## Technical Information Service 55/21 ENU 1378

## Removing and Installing Drive Belt: Observe Specified Procedure (55/21)

Vehicle Type: Panamera Turbo (971)/Panamera Turbo S E-Hybrid (971)/Panamera GTS (971)

Concerns: Belt tensioner

Belt tensioner

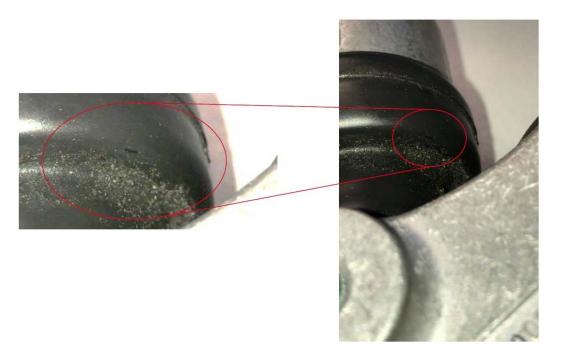
Information: Internal tests have shown that the dust boot on the belt tensioner can be damaged by relieving

the tension on the belt tensioner too much (fully) when removing or installing the drive belt.

For this reason, when removing and installing the drive belt, make sure that you only relieve the tension on the belt tensioner as much as required to allow you to remove and install the drive belt. There is no need

to relieve the tension on the belt tensioner fully for removing and installing the drive belt.
